City of Kingston
Report to Kingston Heritage Properties Committee
Report Number HP-24-043

Subject: Applications for Ontario Heritage Act Approval

Address: 411 Wellington Street (P18-520)

File Numbers: P18-095-2024, P18-096-2024, P18-097-2024, P18-098-2024, P18-099-2024 and P18-101-2024

RIGHT ELEVATION

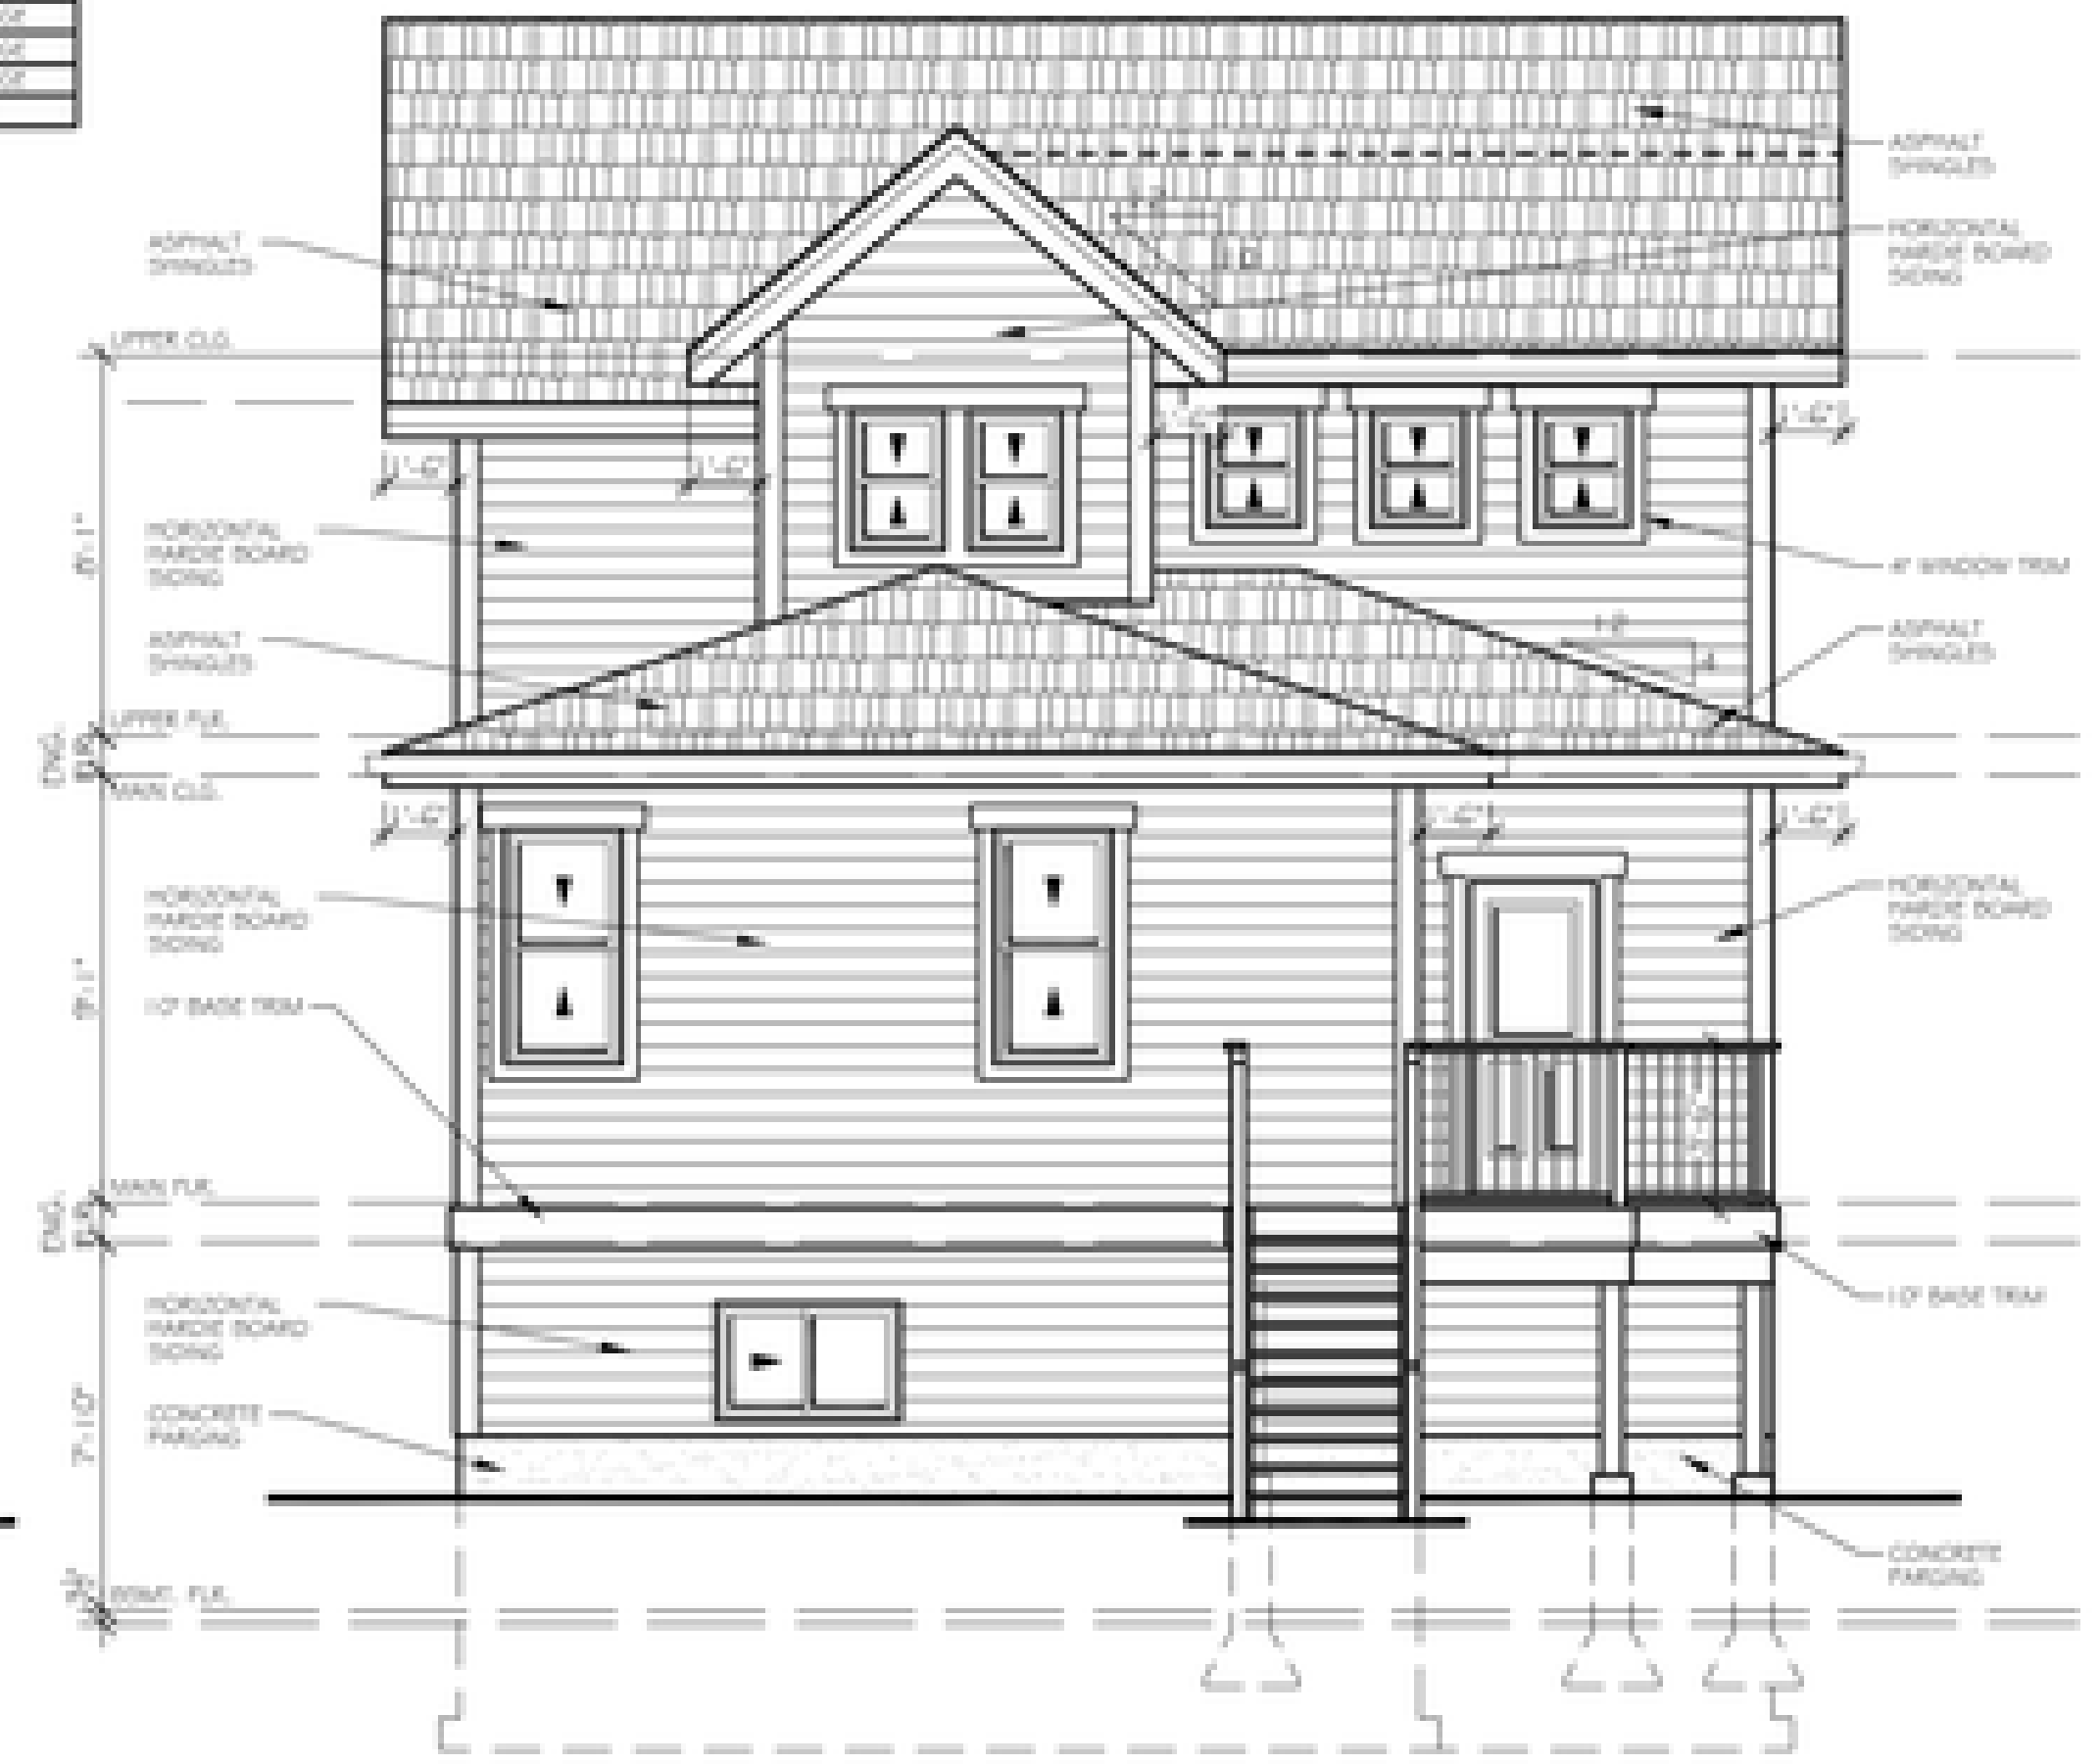
The subject Lot is located on the western side of Old Kiln Crescent and central within the subdivision. The proposed design of the new dwelling conforms to the policies of the District Plan and is supportable. During the review of this application, staff noted the addition of a projecting gable on the front porch roof. While not a requirement and not an egregious deviation from the goals and objectives of the District Plan, the addition of the decorative roof feature on the primary front porch does not align with the heritage character of the HCD, which emphasizes simple roofs. Staff have included a condition of approval to require the owner to consider amending the front porch plan to remove the extra roof feature.

1. The applicant shall consider amending the design of the front porch to remove the central gable on the porch roof;
2. The applicant shall consider reducing the amount of glazing on the street facing elevation of the property, and that the use of vertically oriented single sash windows on the front elevation is encouraged and permitted as an option to the double windows proposed;

LOCATION
**254 OLD KILN CRES.
KINGSTON, ONTARIO**

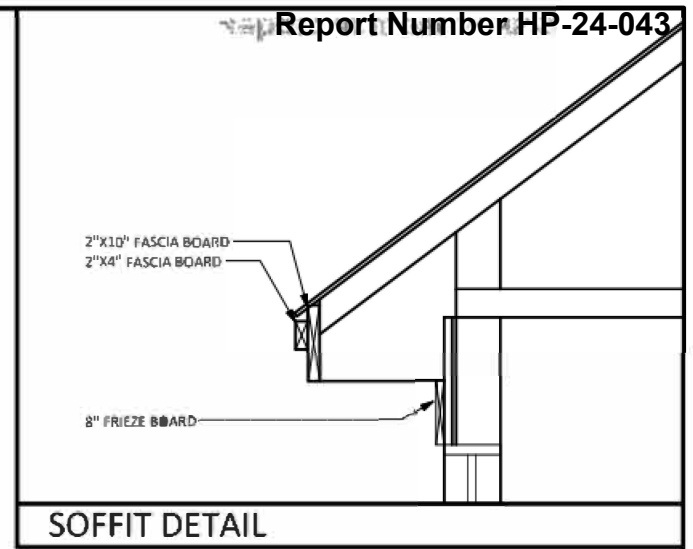
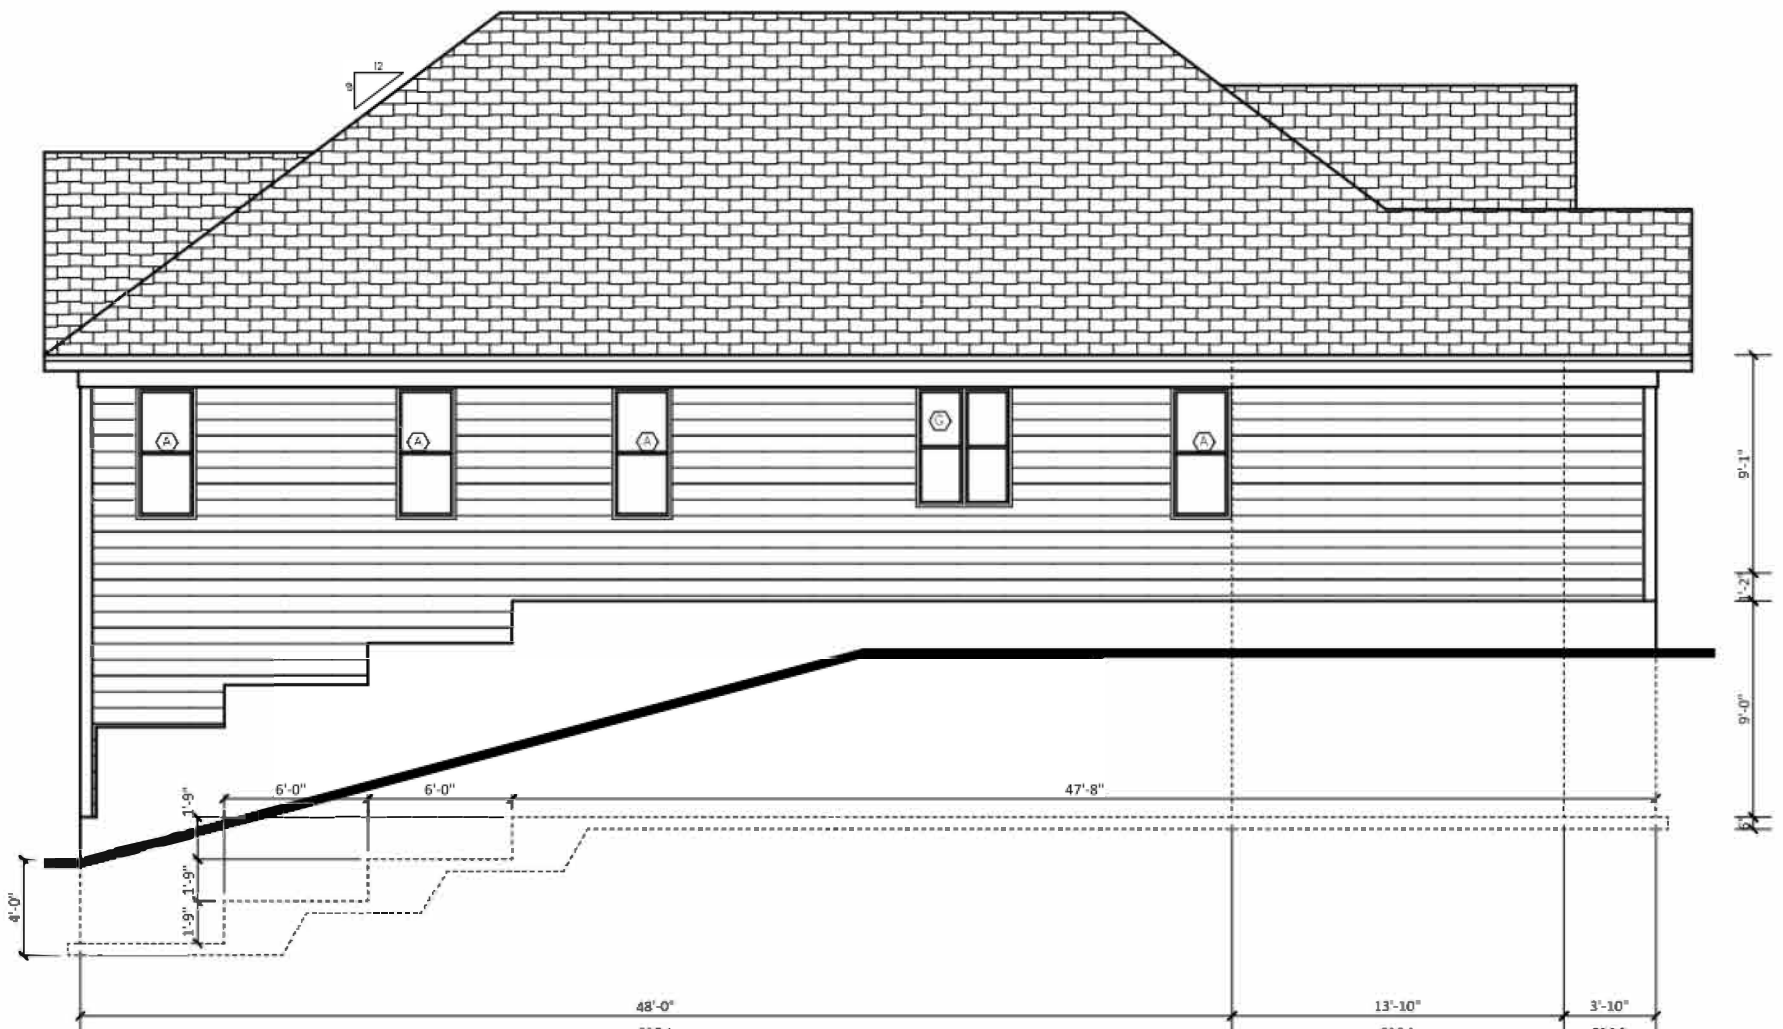
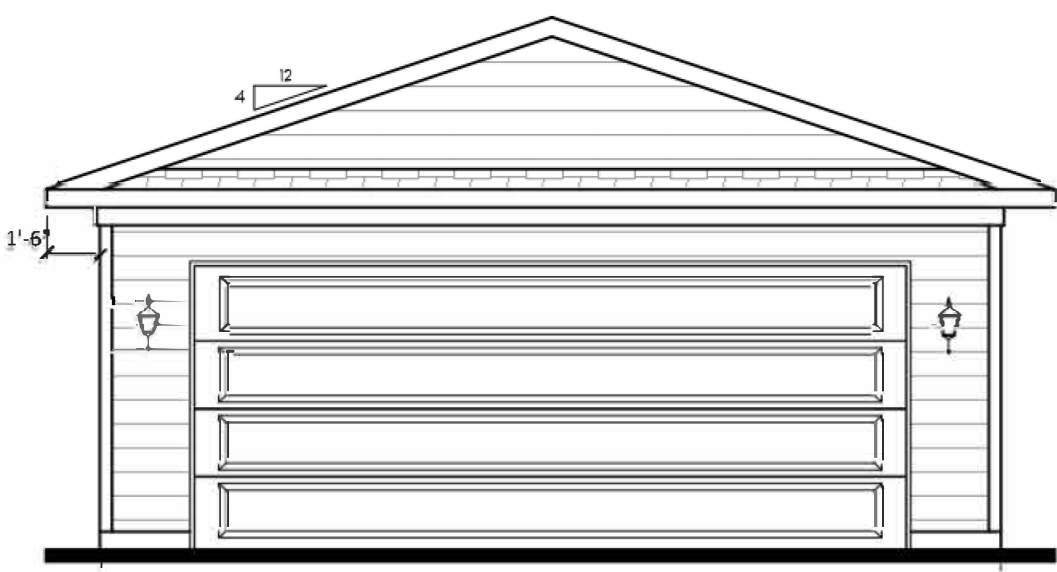
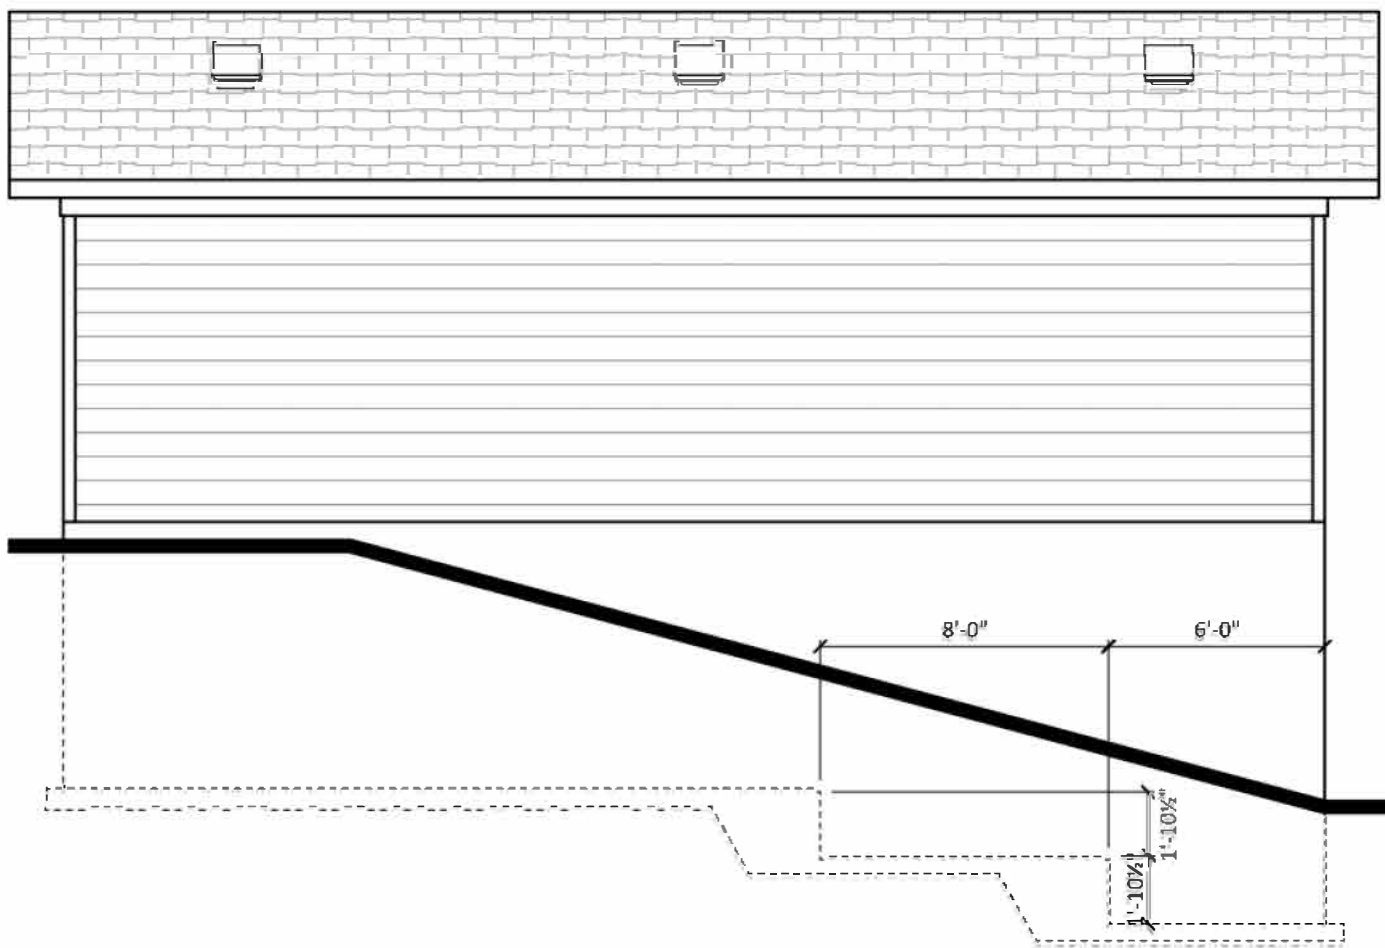
complex hipped roof style with multiple gable projections on the front elevation, is not in keeping with the heritage character in the HCD, as outlined in the District Plan.

While the single storey, all wood-clad building will be a welcome addition to the area, the complex roof design conflicts with both the vernacular design of traditional buildings in the area, as well as the heritage character of the HCD as outlined in the District Plan. Staff provided this concern to the applicants, who attended a Roundtable meeting to discuss options. It was suggested that the primary ridgeline could be extended forward to simplify the roof design. No change to the proposal has been made at the time of writing this report. A condition of approval has been included to require the applicants to amend their plans to reflect a more traditional roof design.

2. The roof profile shall be amended to reflect an end-gable or side-gable style roof, to the satisfaction of Heritage Planning staff;
3. The detached garage shall be located beyond (to the rear of) the front wall of the main dwelling;
